Re: WAITES WHARF PROPOSED DEVELOPMENT; 3rd FOW LETTER

City of Newport Planning Board
City Hall
43 Broadway
Newport, Rhode Island 02840

Re: Harbour Rlty; The plans admit the true ROW width is 23' (but envision merely 20').

RE: Petition of Harbour Realty, LLC (Waite's Wharf proposal), Friends of the Waterfront's comments submitted in anticipation of Planning Board meeting to be held March 7, 2022.

Excerpt of the traffic report (p. 2). Highlighting is added to the admission that the ROW is well more than 20'.

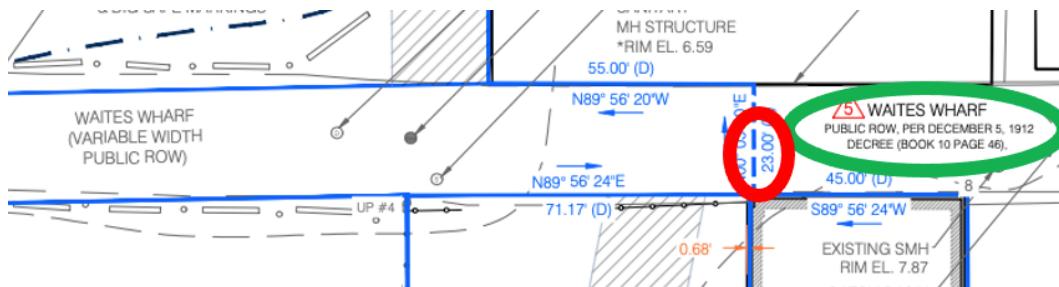
Before turning to the engineering plans, a brief detour to the other parts of the application is in order. In particular, the Traffic Impact Analysis filed in February contains this admission:

Thus, the applicant's own expert states the width. The expert's use of the word "approximately" cannot be used to cover a 20% reduction, which is what the applicant's proposal contemplates.

Excerpt of current conditions plan. Red circling is added where the applicant admits that the ROW is 23-feet wide. Green circling is added to a cross-reference that is discussed below.

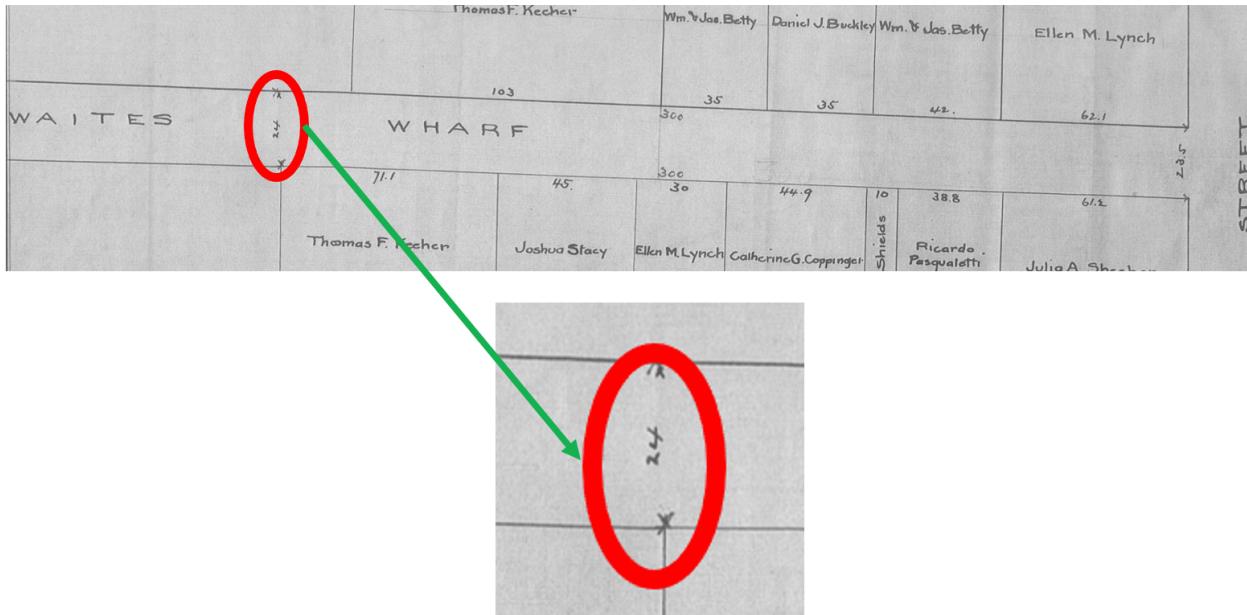
- **The current conditions Survey Plan depicts Waite's Wharf ROW as 23-feet wide.**

In the engineering packet, after the cover sheet, is Sheet 1 — the master existing conditions drawing entitled Survey Plan. This affirms that the Waite's Wharf ROW is 23 feet wide:

Circled in green on the above excerpt is a Book & Page citation that appears to be a LER reference but that, upon investigation, is actually a reference to old Board of Aldermen records. This leads to a 1912 map, formally adopted by the City leadership, that further proves a relatively wide ROW:

Excerpt of demolition plan. Red circling is added where the applicant again admits that the ROW is 23-feet wide.

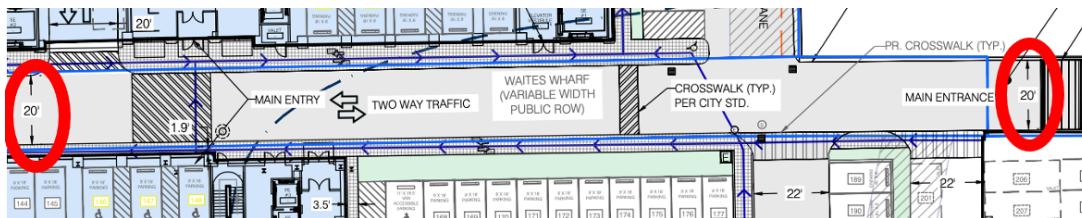
- **The Demolition & Staging Plan also depicts Waite's Wharf ROW as 23-feet wide.**

In the same packet is Sheet 4 — Demolition & Staging Plan. This depicts the site during the work:

Excerpt of the latest Proposed Site Plan. Red circling is added where the ROW width is changed to show 20-feet.

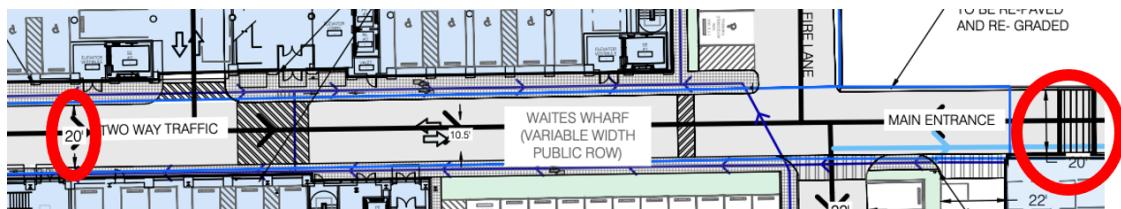
- **The Proposed Site Plan flip-flops to depict Waite's Wharf ROW as only 20-feet.**

In the same packet is Sheet 5 —entitled Proposed Site Plan. This contradicts the prior plans:

Figuratively and literally, the applicant must go back to the drawing board. Respectfully, FOW asks that the Board require this. In particular, the applicant should revise all plans using the correct ROW measure of 23’ and should make the other revisions indicated.

Plan showing north-south sewer easement perpendicular to two ROWs: West Extension St. and Waite's Wharf.

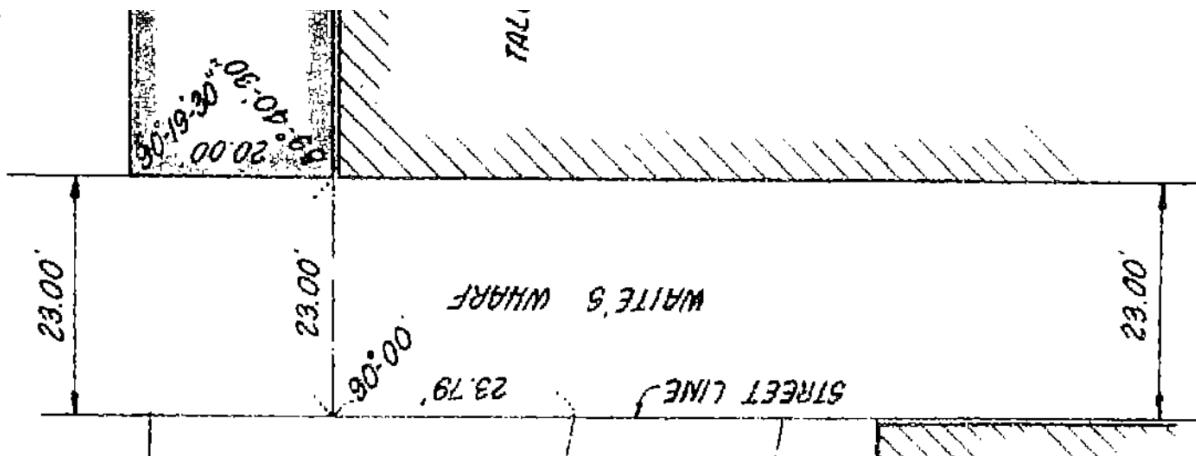
This leads to the plan (Clerk's Document #197722), which shows a sewer easement forming a strip extending from West Extension Street southerly to Waite's Wharf in a perpendicular manner:

The sewer easement is of no import here. It is Waite's Wharf that we are concerned with. The delineation of Waite's Wharf is unmistakable in that the phrase "Street Line" is employed:

Importantly, the width of 23 feet is noted three times; the private abutter and the City agreed on this figure. An abutter would resist undue widening. Here, twenty-three feet is conceded.

Excerpt of current proposed plan with green framing added to the area corresponding to the magnification of the 1977 plan. Red circling is added to the areas where the current applicant represents that the ROW is 20-feet wide.

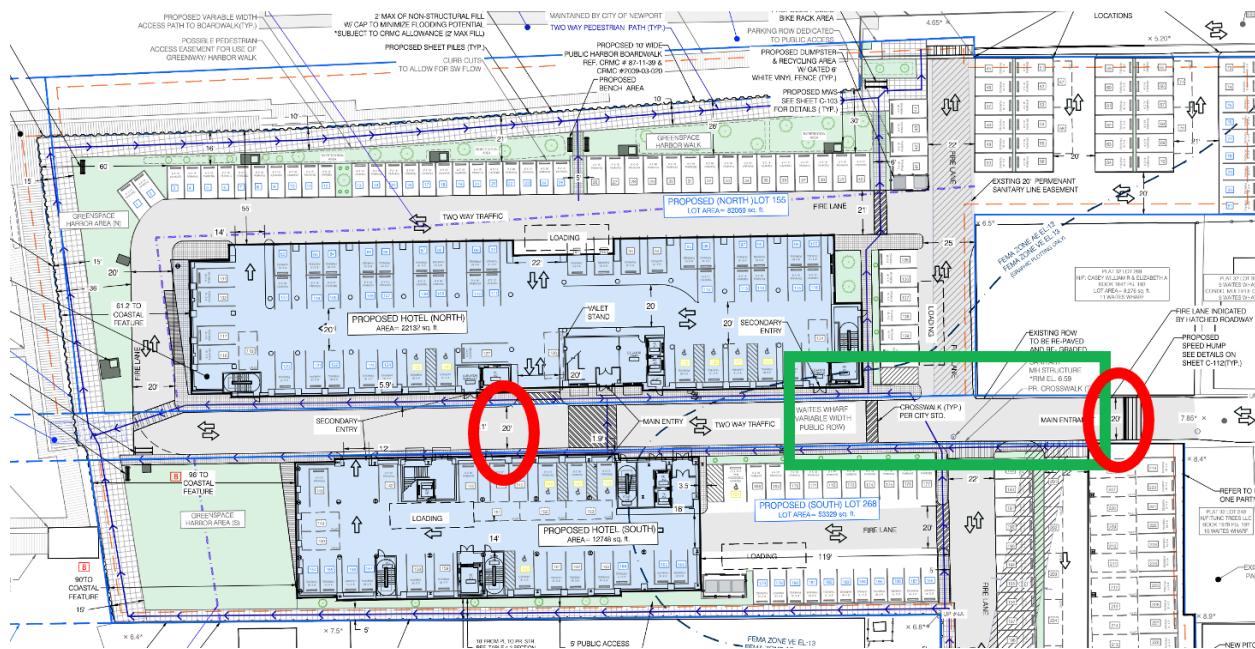
It is instructive to excerpt the current proposed plan, now pending before the Board, and then mark it to approximately highlight (frame) the area depicted in the above excerpt of the 1977 Plan:

This juxtaposition shows that the very stretch of roadway that was mutually acknowledged to be 23-feet wide is now misleadingly presented as merely 20-feet wide. The Board will note that the area framed in green is situated squarely between the two measurement notations indicating the purported shorter distance of 20 feet across the ROW, both of which I have circled in red.

The Board can see the discrepancy. Respectfully, the current proposal must be summarily dismissed. The additional three feet due to the public will require a complete re-engineering.

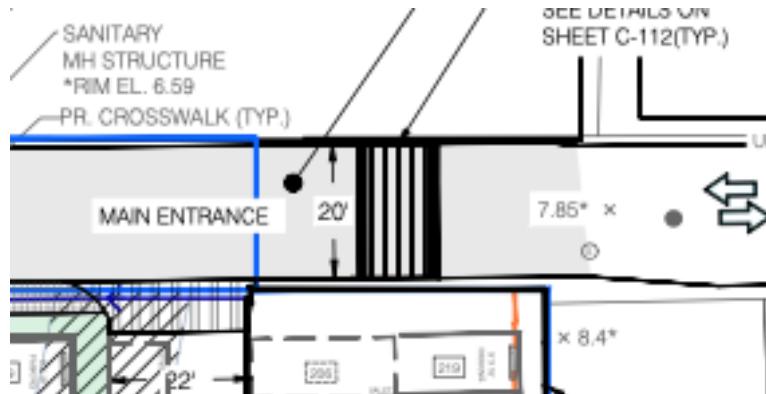
If that were not enough, two other 1977 plans — each respectively made by predecessors of other lots that form part of the subject land — reaffirm that Waite's Wharf is 23 feet in width. See Clerk's Document #197720 (by the predecessor-owner of APL 32/293) and Clerk's Document #197721 (by the predecessor-owner of APL 32/272). In sum, three predecessors plus the City all agreed.
